CITY of NOVI CITY COUNCIL

Agenda Item 2
December 19, 2016

SUBJECT: Approval at the request of McBride Dale Clarion for the Speedway at 14 Mile and Haggerty, JSP 16-13, with Zoning Map Amendment 18.714, to rezone property in Section 1, located at the southwest corner of Fourteen Mile Road and Haggerty Road from OST (Planned Office Service Technology) and B-3 (General Business) to B-3 (General Business) subject to the related Planned Rezoning Overlay (PRO) Agreement and corresponding PRO Plan. The property totals 2.03 acres and the applicant is proposing to update and rebuild the whole site.

JSP16-13: Speedway 14 Mile/Haggerty - PRO

DRIVEWAY LOCATION PLAN
REBUILD
31275 HAGGERTY ROAD
OKLAHOMA COUNTY
NOVA, MI

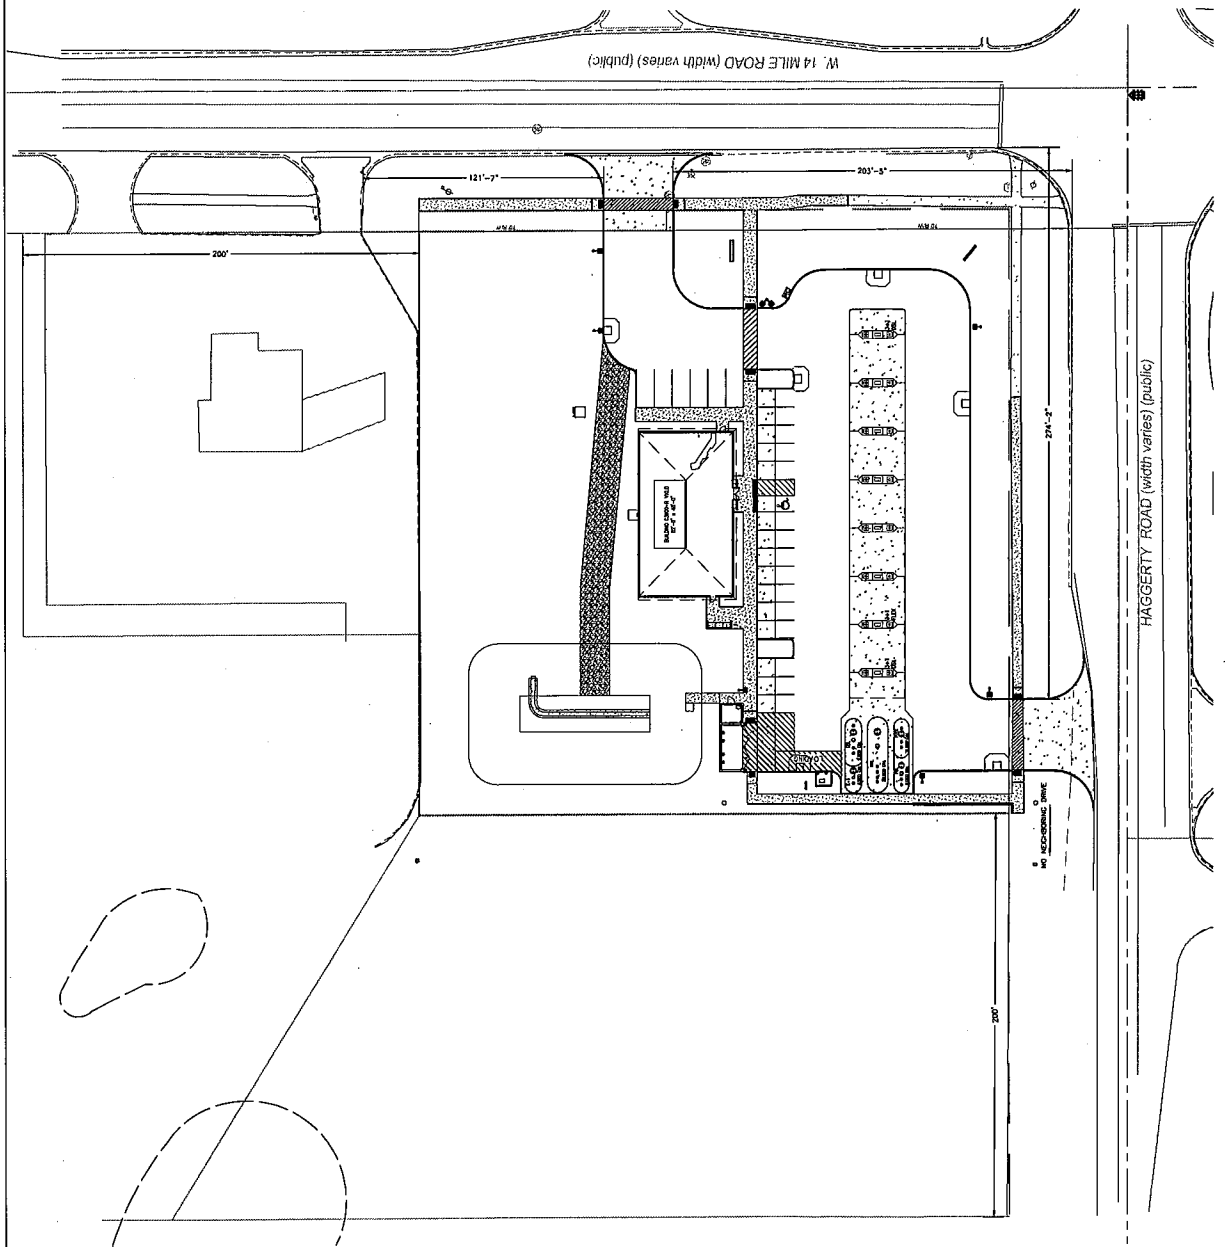
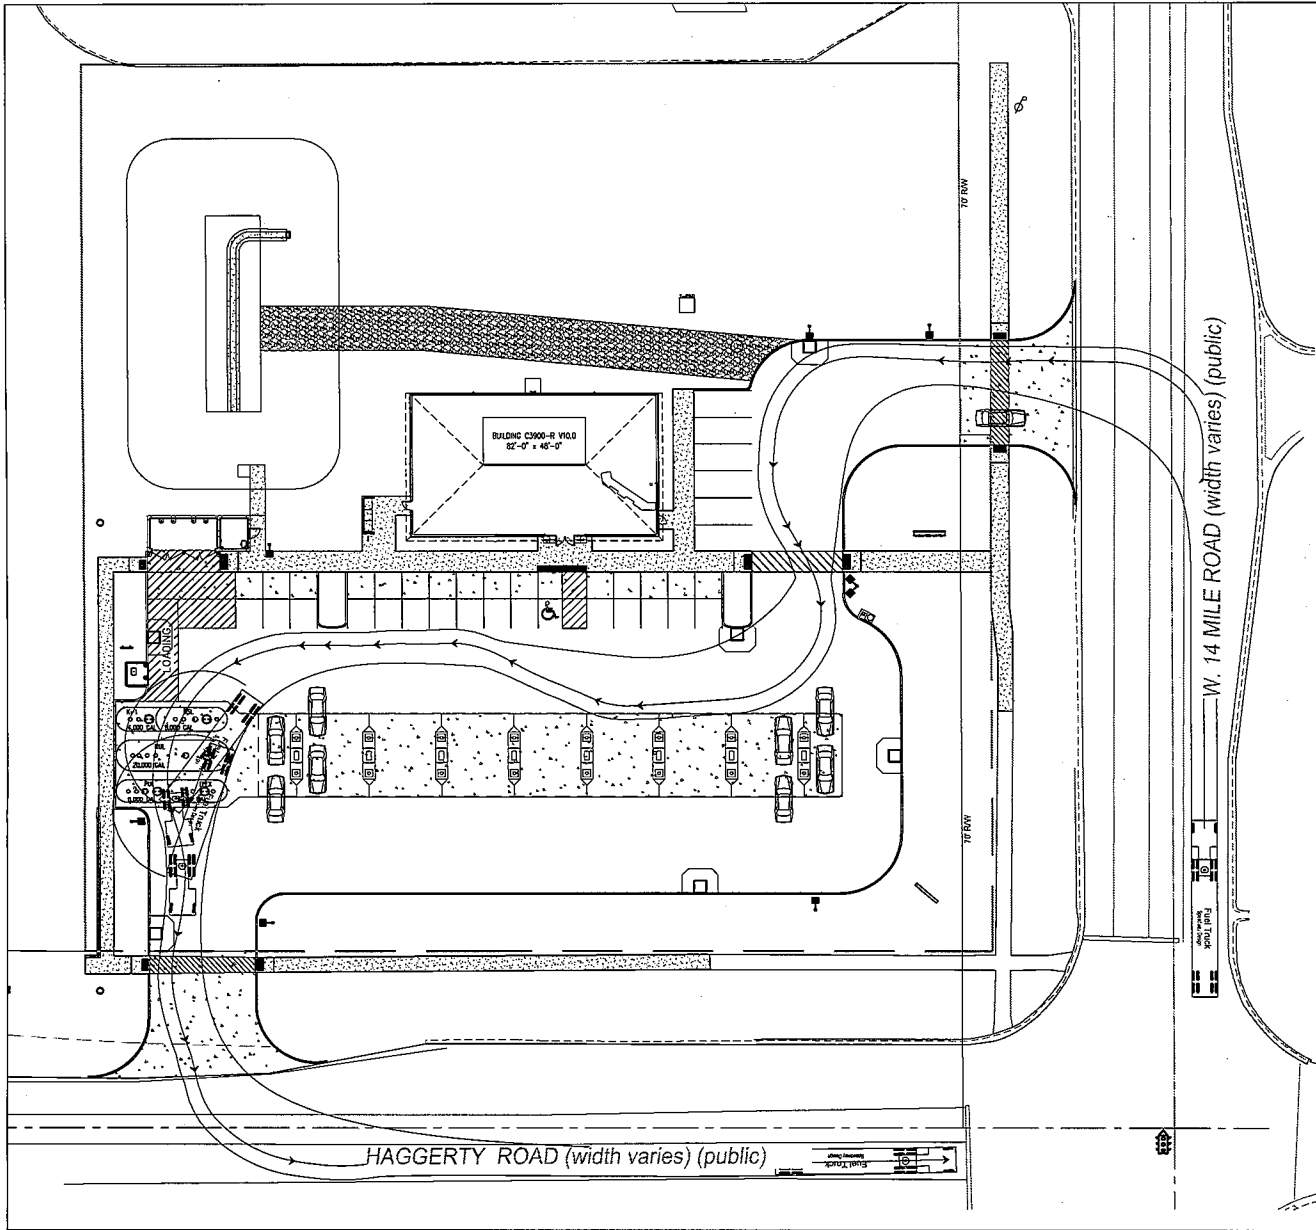
- a. A same side driveway spacing waiver to allow the driveway on 14 Mile Road to be located approximately 121 feet (200 feet required) from the neighboring driveway to the west to align with existing driveway on the north side of 14 Mile Road.

- b. An opposite side driveway spacing waiver to allow the driveway on Haggerty Road to be located approximately 40 feet (200 feet required) from the driveway to the south in order to align with the existing driveway on the east side of Haggerty Road.

- The driveway entrance widths are in compliance with City standards.
- Driveway radii should be labeled in order to ensure compliance with City standards.
- The proposed driveway along Haggerty Road is being shifted to the south and is now located in part of the existing taper section, which is not ideal if it can be avoided
- The applicant should review Figure IX.11 of the City's Code of Ordinances and provide the applicable taper and/or acceleration/deceleration lanes as required.
 - A gasoline station with convenience market with 16 fueling stations is expected to generate 217 trips during the PM peak hour based on the ITE Trip Generation Manual, 9th Edition (ITE Code 945). If equal distribution were to be assumed at both driveways and among left and right-turning vehicles, there would be approximately 27 right turning vehicles during the PM peak hour at each of the site driveways.

2224
 PROJECT # 95505
 SCALE 1/8" = 1'-0"
 DATE 11/18/11
 DRAWN BY JTP
 CHECKED BY JTP
 DATE 11/18/11
 2224-ELE

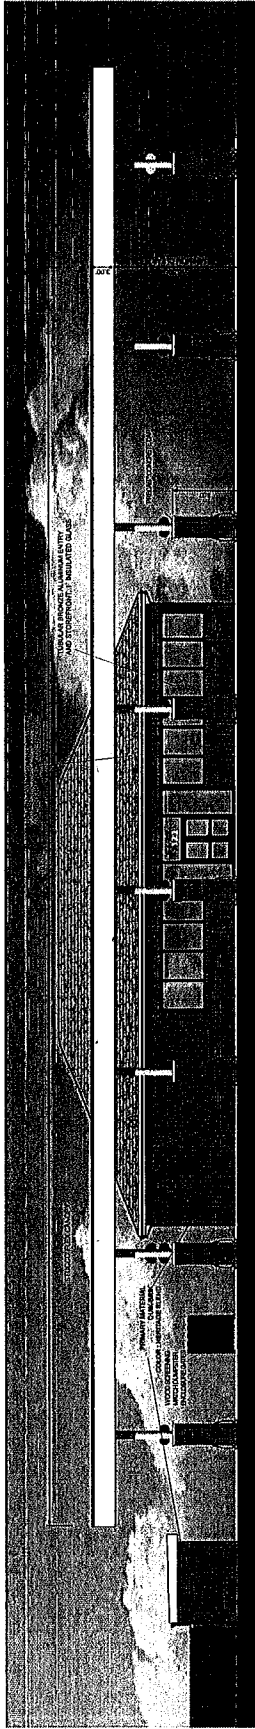
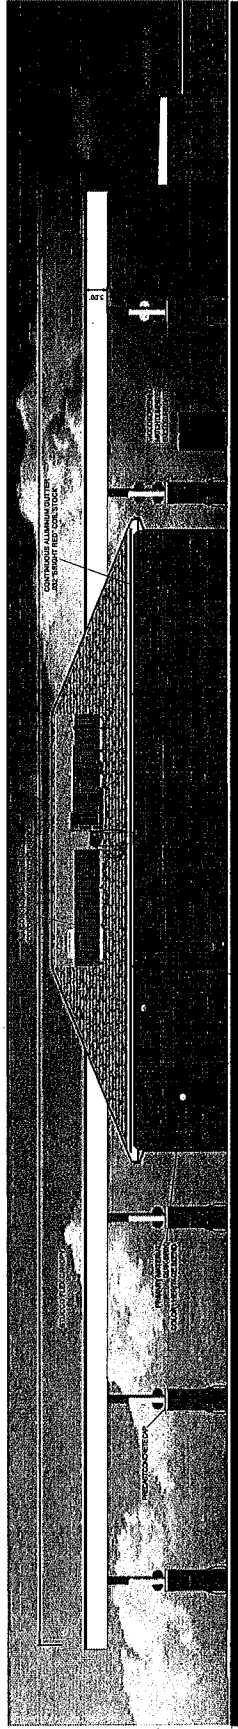
- c. Section 9 Façade Waiver for the overage of Asphalt Shingles on the building (maximum 25 percent permitted; proposed 51 percent on east, 35 percent on west, 30 percent on south and north).

1. Speedway is requesting a waiver for the asphalt shingles as shown on the building elevations. See sheet 2224-ELE.
2. Speedway is requesting approval of the elevations as provided in the submittal packet.
3. Speedway will work with staff on the revised elevations to ensure compliance with City regulations.
